National Dam Inspection Program.
Duck Harbor Pond Dam (NDI ID Number
PA-00144, DER ID Number 64-54), Dela-
ware River Basin, Little Equinunk Creek,
Wayne County, Pennsylvania. Phase I
Inspection Report,

DUCK HARBOR POND DAM

PHASE I INSPECTION REPORT
NATIONAL DAM INSPECTION PROGRAM

DUCK HARBOR POND DAM
 NDI ID No. PA-00144; DER ID No. 64-54
 PHASE I INSPECTION REPORT
 NATIONAL DAM INSPECTION PROGRAM

RESULTS OF
VISUAL INSPECTION

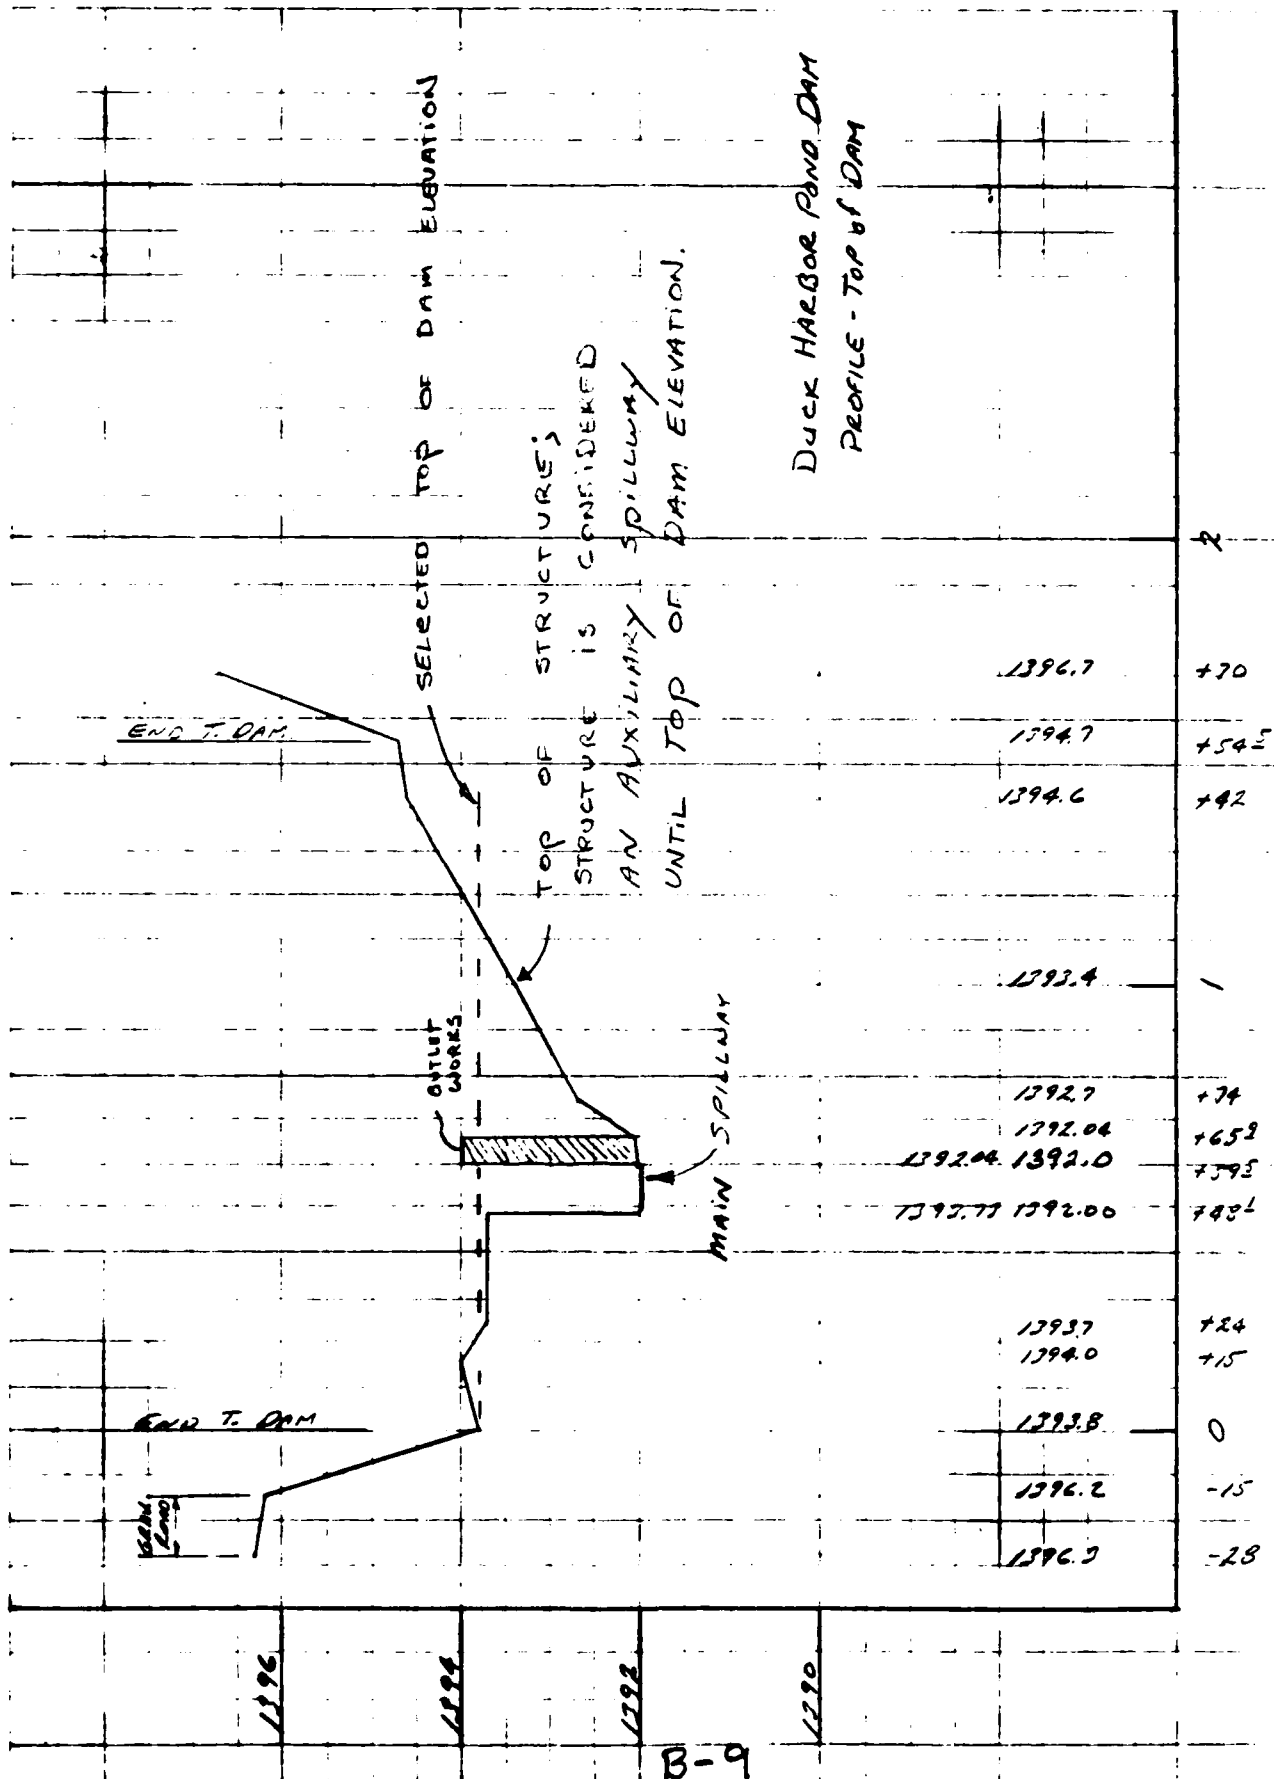
SEEPAGE
FROM BENEATH
ROCKS
60 GPM

DEPRESSION
IN TOP

DISPLACED STONES
ALONG TOP

MATURE TREES
ALONG TOE

(1) As part of the regular maintenance program, remove trees growing along the toe of the dam and replace the missing stones at the top of the dam.

(2) Expand the regular inspection program to include monitoring of concrete spalling and seepage. Take appropriate action if conditions worsen.
